COIN MECHANISMS INC.
 400 REGENCY DR.
 GLENDALE HGTS, IL

TITLE PCB, CTRL, CC62, 12VDC , S17msC11msE11ms, INH, SC			
DRAWN	SS	DATE	9/8/87
CHKD		DATE	
APP		DATE	
DWG NO.	09270011		REV 6
COMP NO.	19270011	SHT 1	OF 3

SCALE	2-1	DATE		
DRAWN	SS	03/16/89		
CHKD				
TITLE				
PCB, CTRL, CC-62, 12VDC, S17msC11msE11ms, INH, SC				
DWG. NO.		09270011	SHEET 2 of 3	B

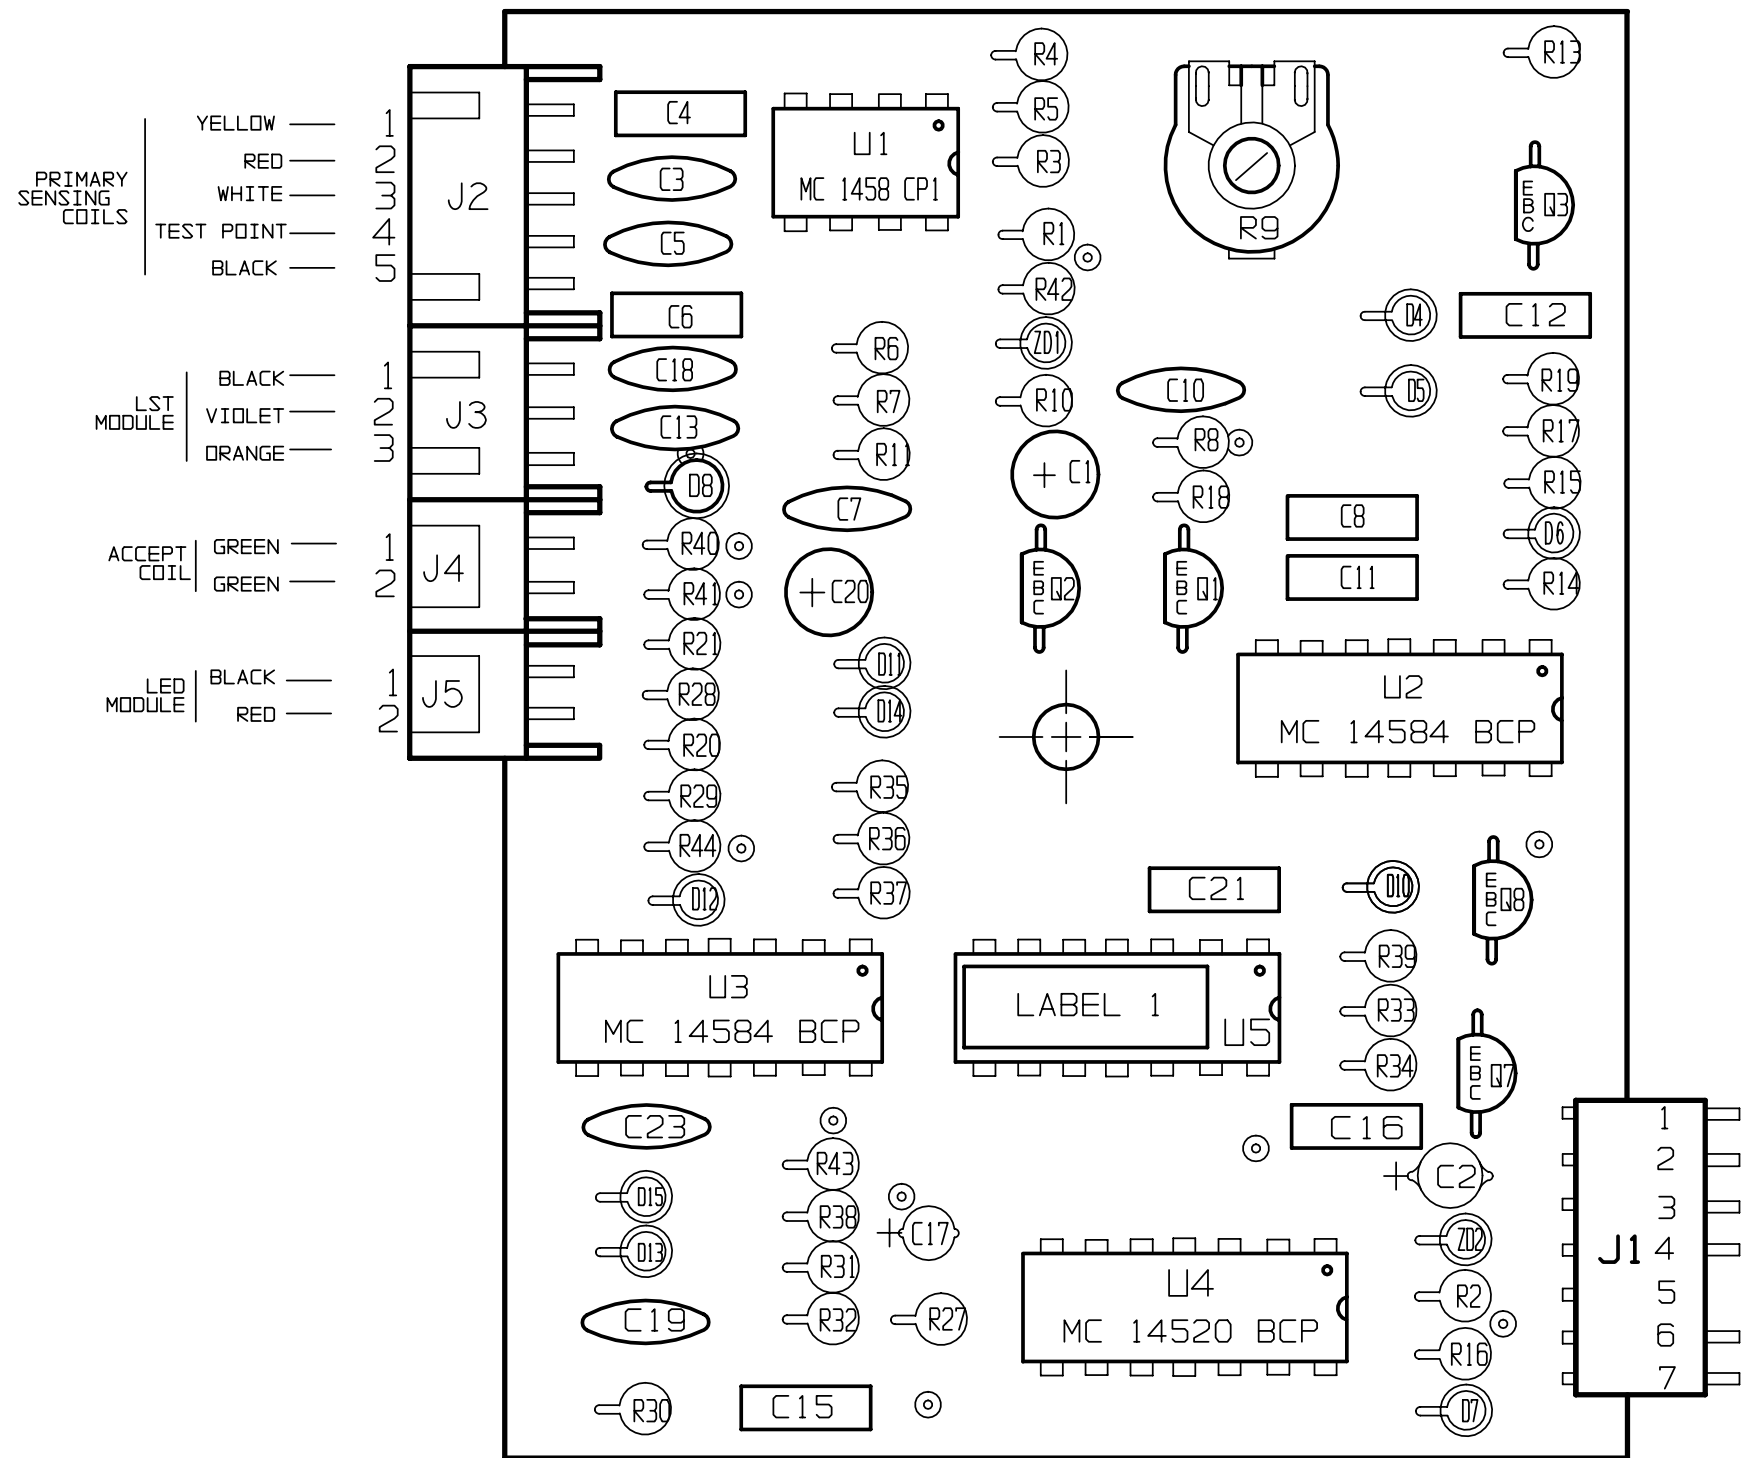
NO.	ECO NO.	REVISIONS	DATE/BY
05	00447	SEE ECOS 00447 AND 00466	9/11/92 GH
	003319	CORRECT PARADOX BOM ERROR FOR R6, R8 AND R16 CHANGE PART DESCRIPTION TO ... PCB, CTRL, CC-62, 12VDC, S17msC10msE11ms, INH, SC PRINT REDRAWN AND UPDATED	8-25-94/SS
	003850 addendum	ADD R20 TO ENG. BOM	6-5-95/SS
	05018	CORRECTED NUMBER SEQUENCE TO MATCH CONNECTOR	11/30/95 LST
06	04188	CHANGED R10 FROM 20K TO 10K TO IMPROVE SELECTIVITY ADJUSTMENT	4/3/96 LST
